Homestead High School Expansion/Renovation Project
Phase 2B - Gymnasium and Auditorium Additions - General Construction
12.9.20
Addendum No. 2

Questions and Front End Clarifications - Pre-Bid Meeting - CSO Architects Addendum No. 2

ADDENDUM NO: 2

PROJECT: Additions & Renovations to Homestead High School
Phase 2B

6 ENLARGED DETAIL UNIT-B HIGH BRICK & CMU WALL
A756-2 SCALE: 1 1/2\"/>

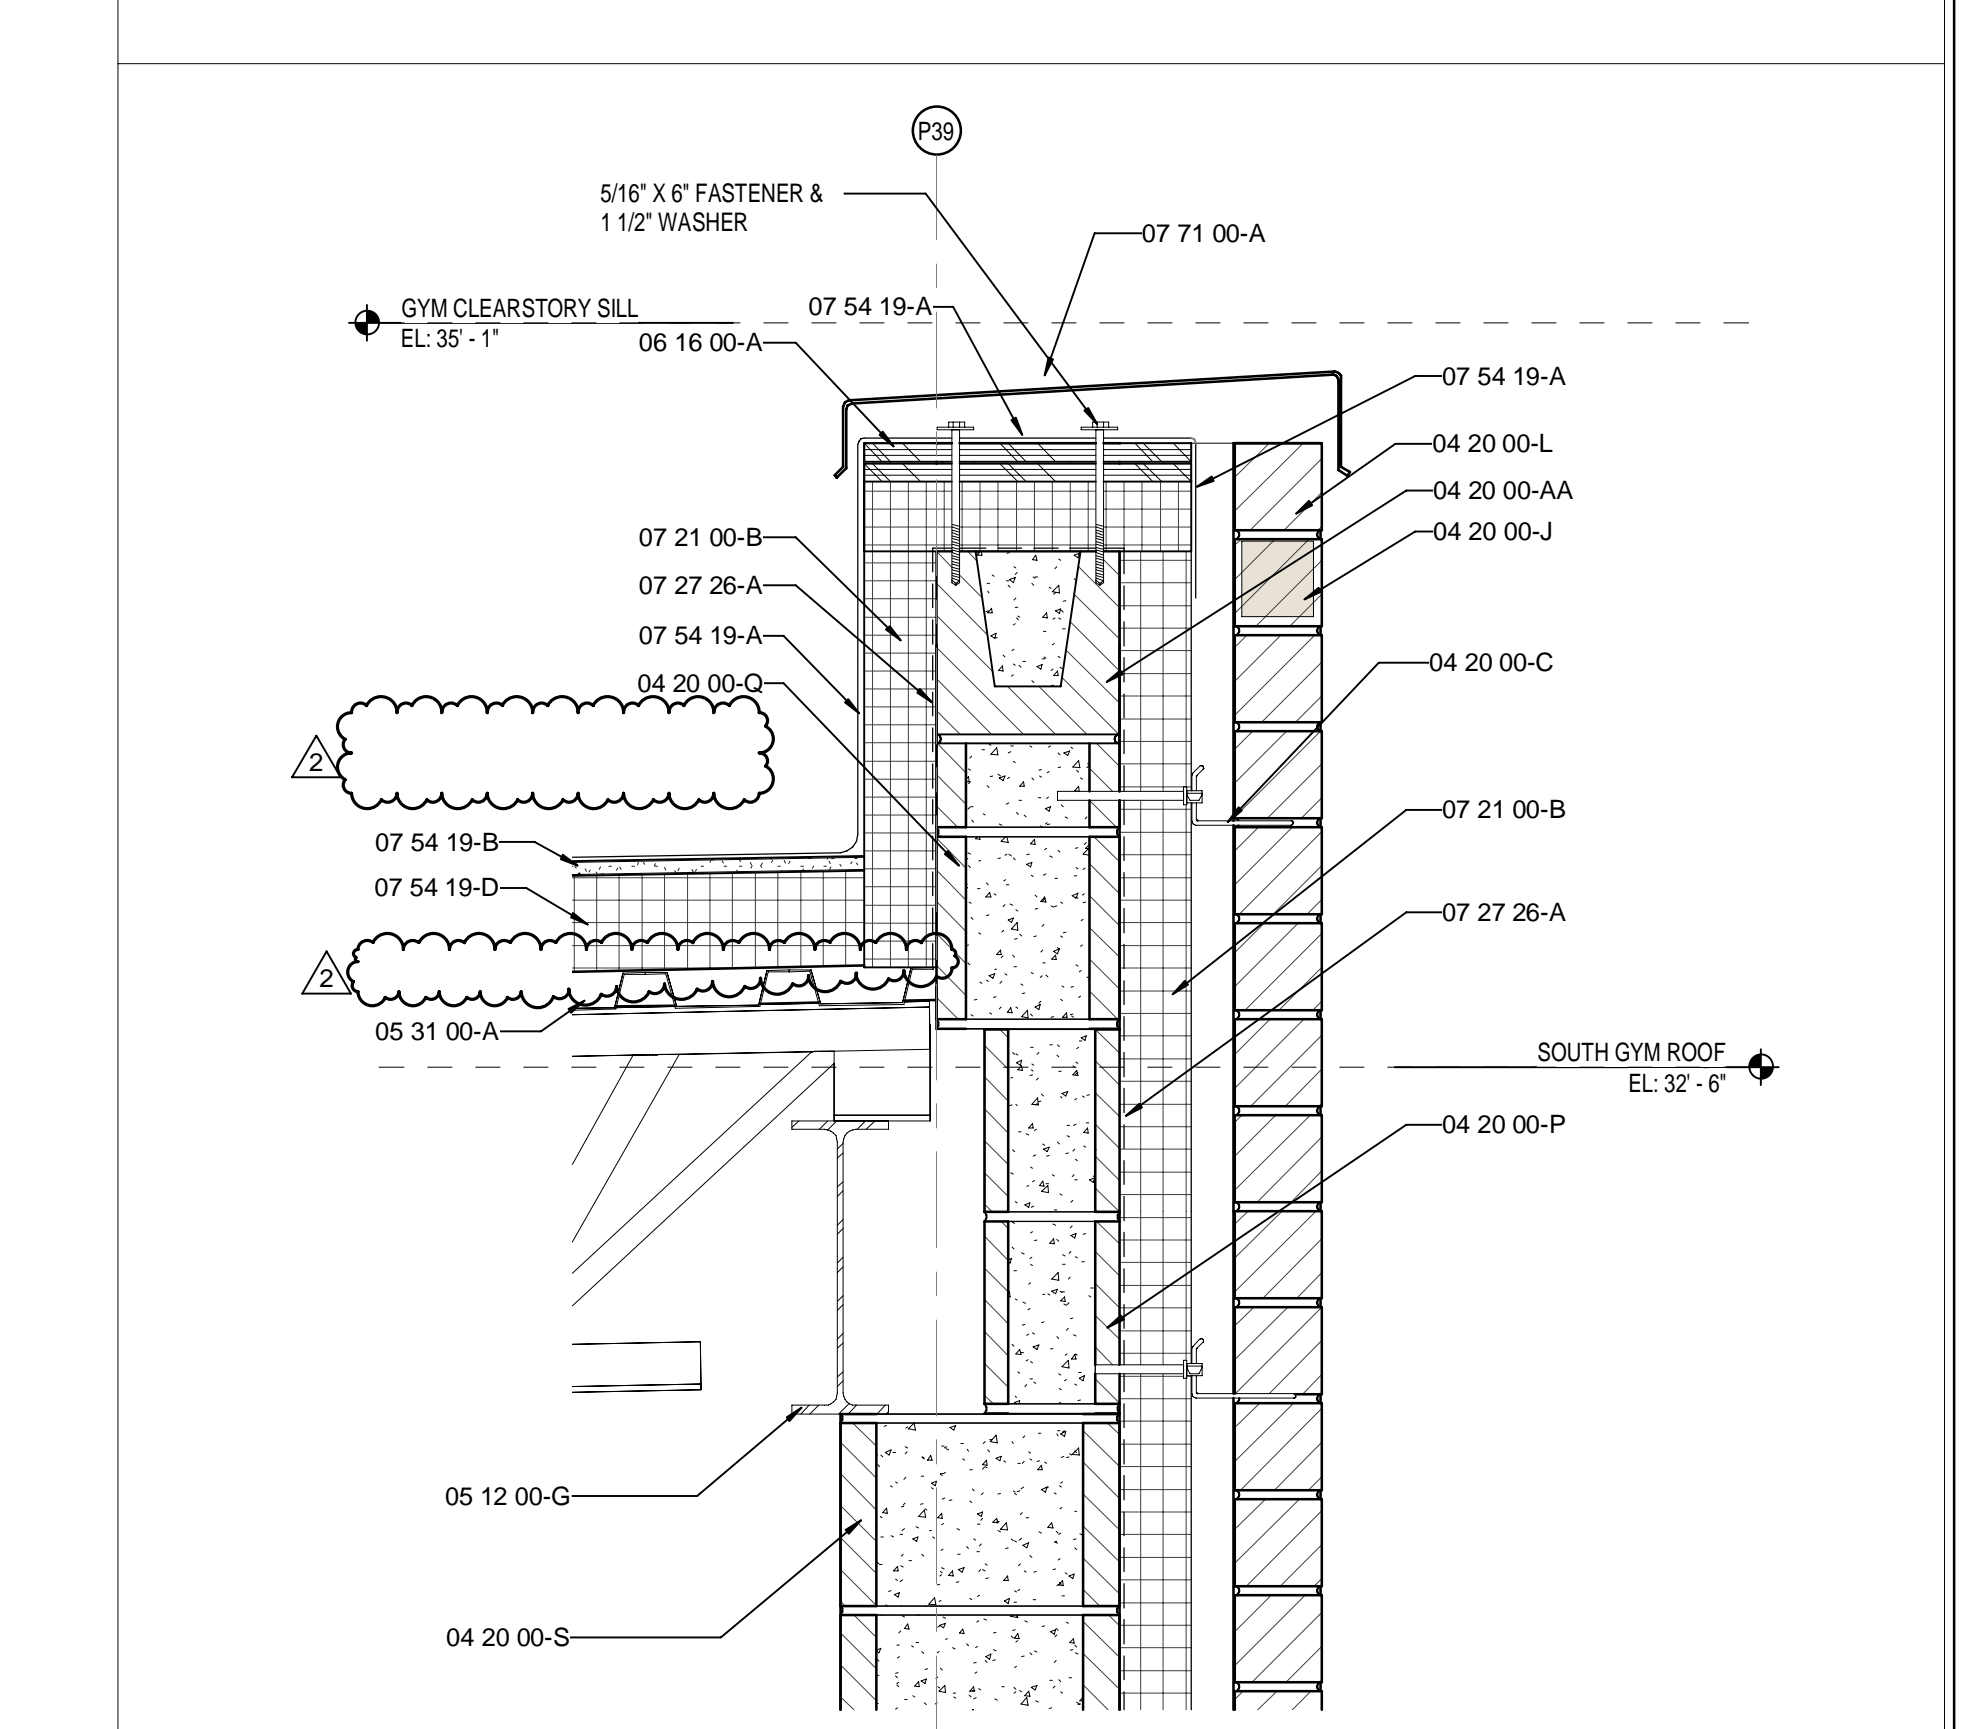
3.012 A756-2 – ENLARGED PLAN DETAILS

- A. Delete roof vapor barrier membrane and ½" gypsum deck board 07 54 19-B at all areas with corrugated metal deck. Note: The only area to receive a roof vapor barrier is at the concrete roof deck at the auditorium.

DRAWING NUMBER
TE311B

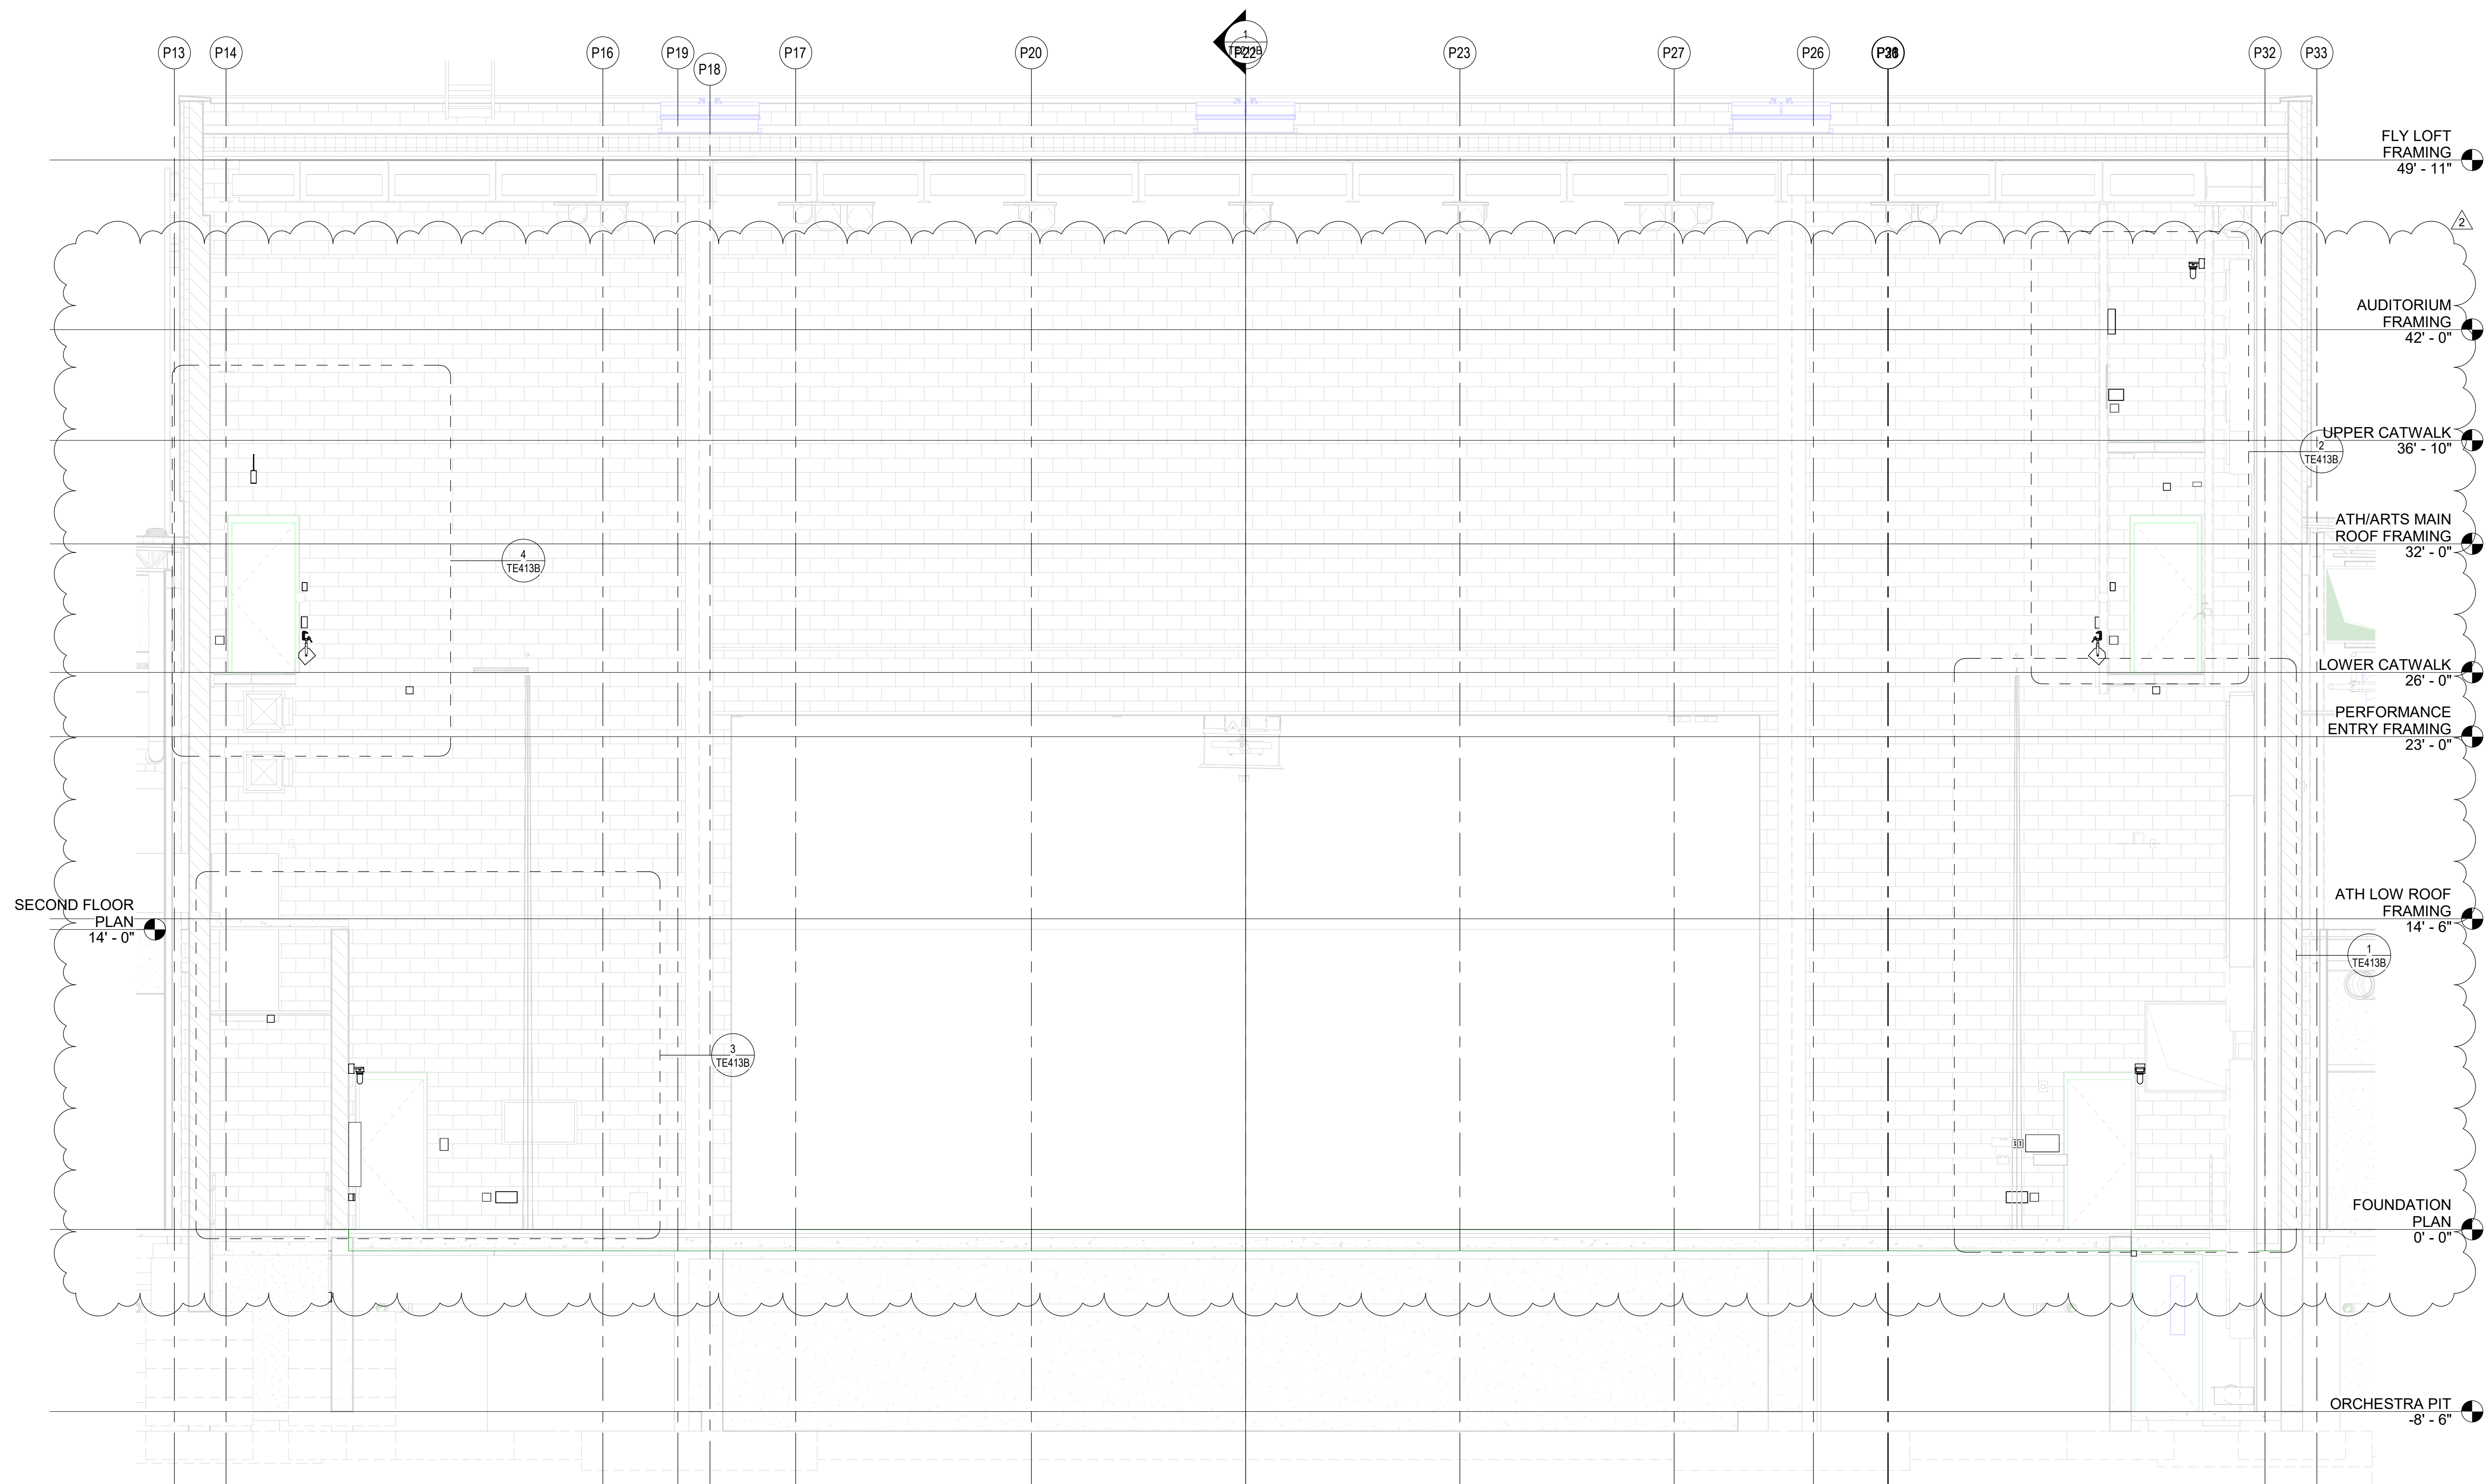
3.023 TE113B – STAGE LIGHTING SYSTEM PROSCENIUM ELEVATION

- A. Add callouts to enlarged elevations

1 PLAN - STAGE RIGGING LAYOUT - STAGE LEVEL
SCALE: 1/4" = 1'-0"

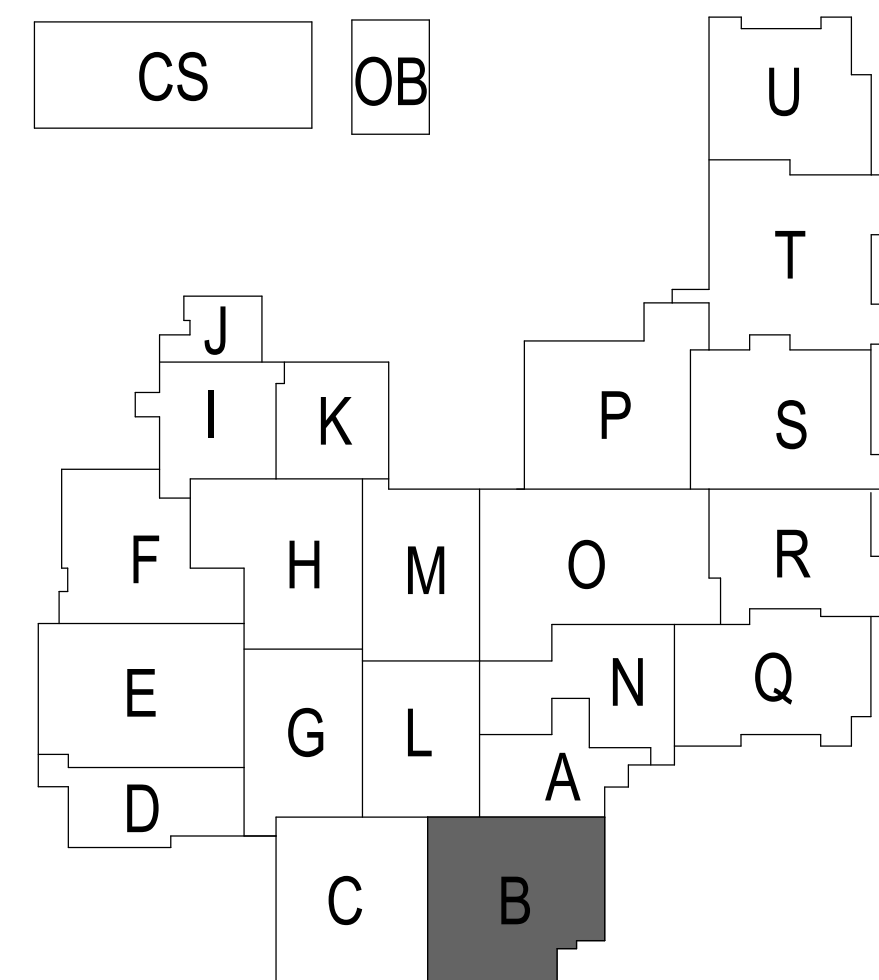
3.029 TR111B – STAGE RIGGING SYSTEM PROSC STAGE LEVEL PLAN

- A. Revise proscenium dimension

2 DETAIL - PROSCENIUM REDUCTION PANEL
SCALE: 3/4" = 1'-0"

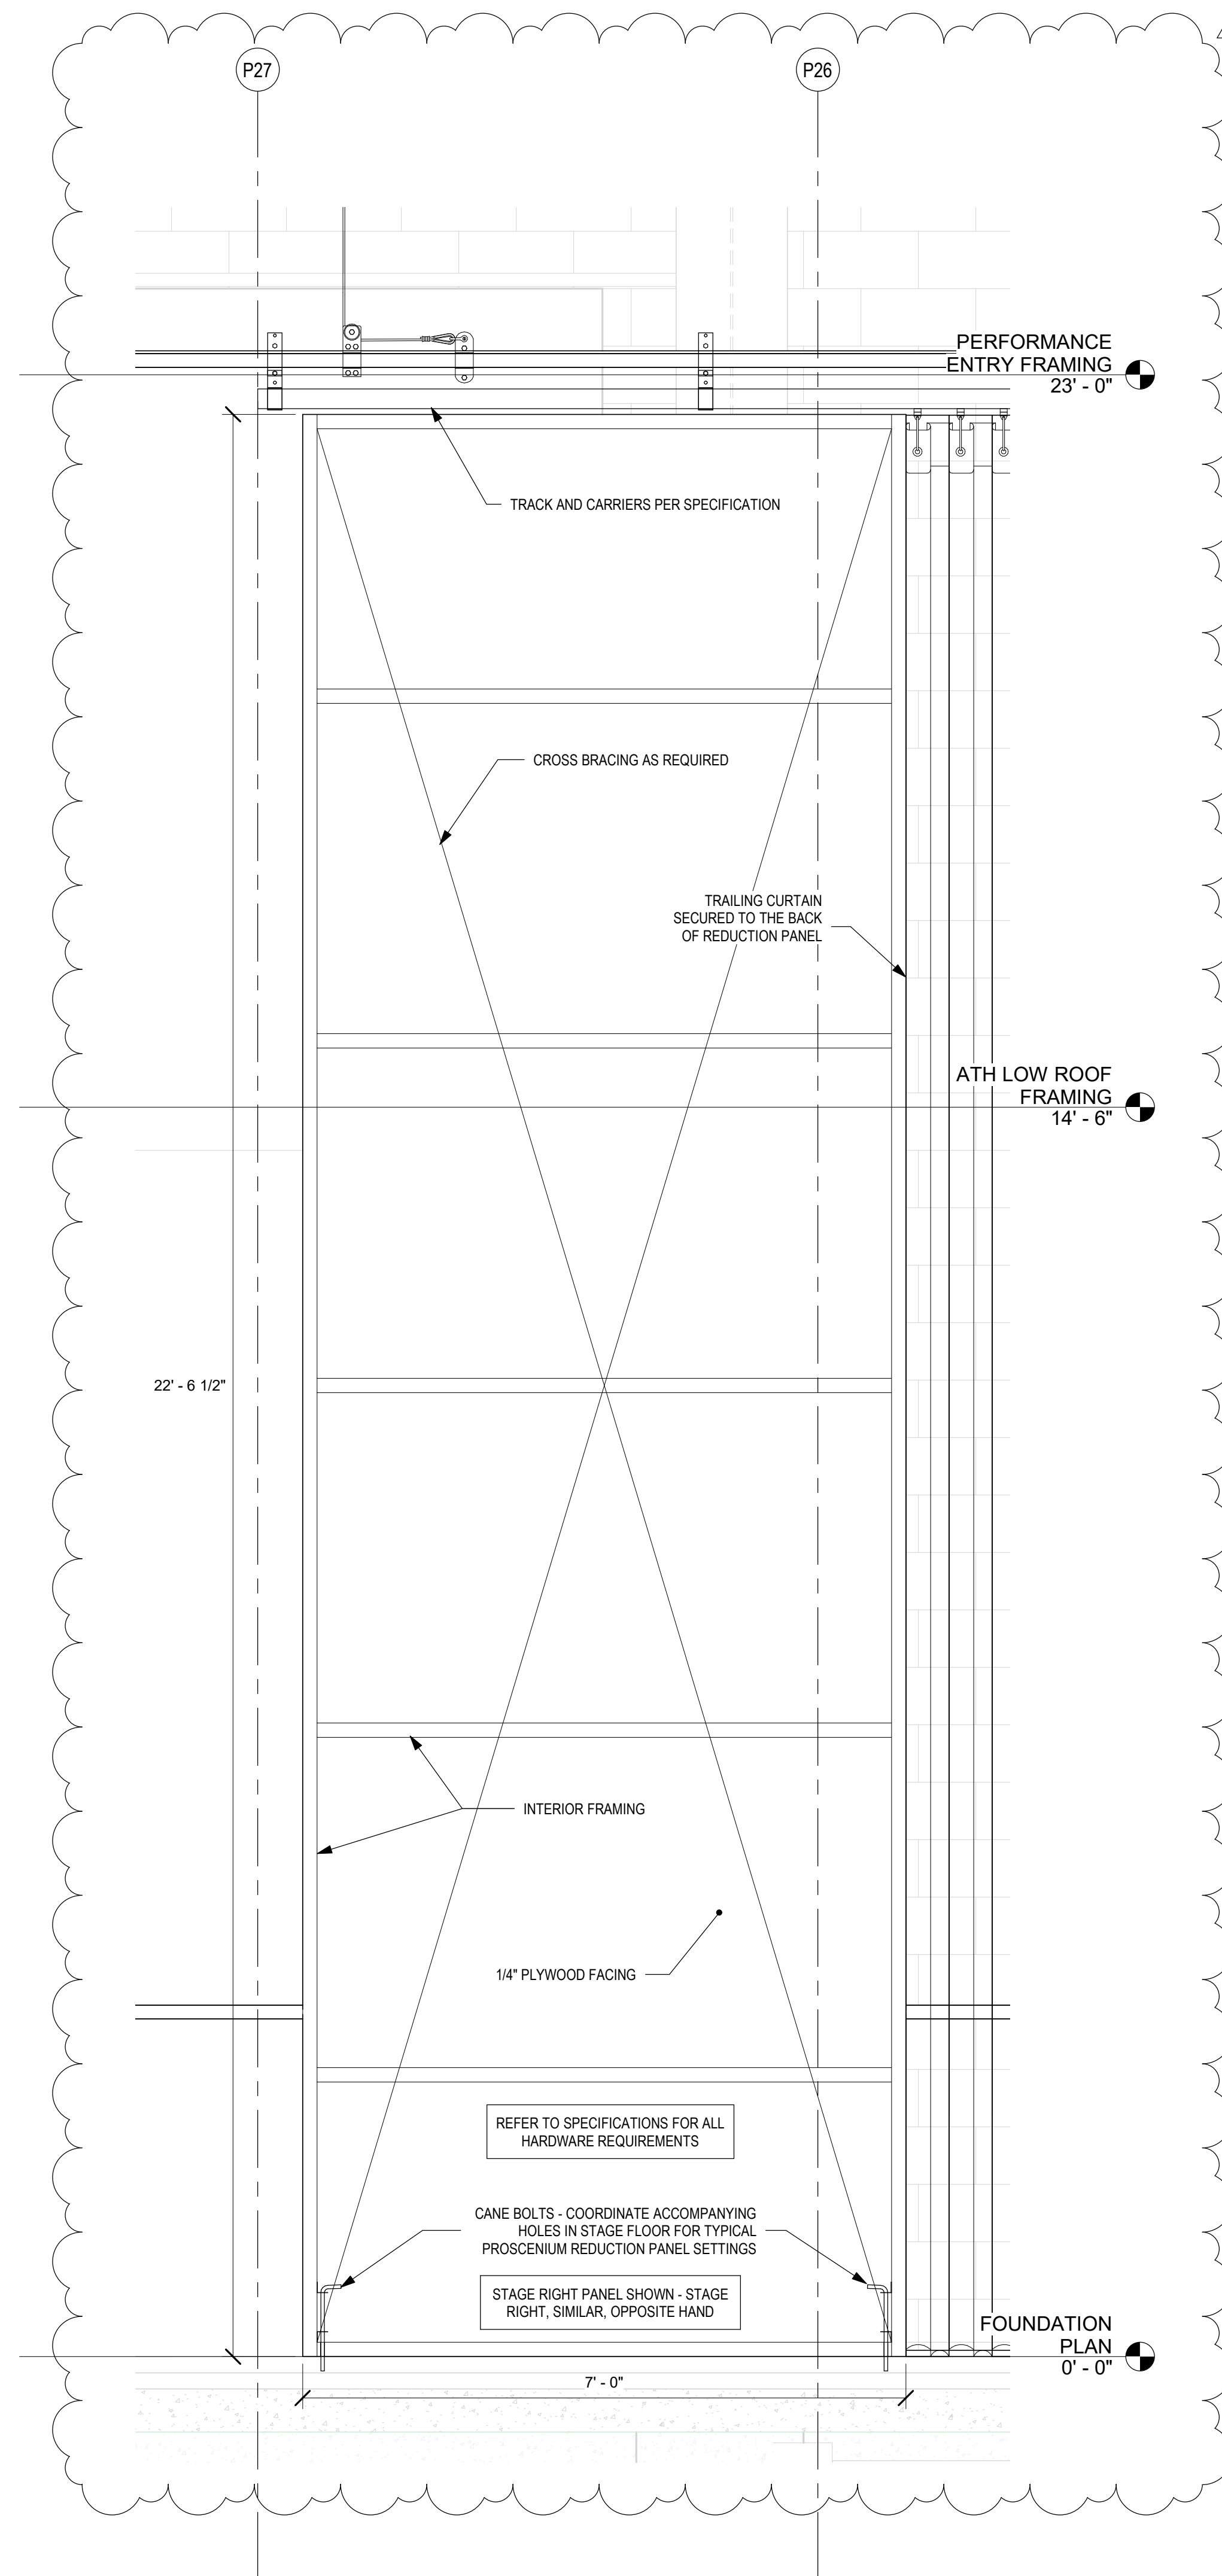
3.030 TR411B – STAGE RIGGING SYSTEM COORDINATION AND DETAIL ENLARGEMENTS

- A. Add Proscenium Reduction Panel detail
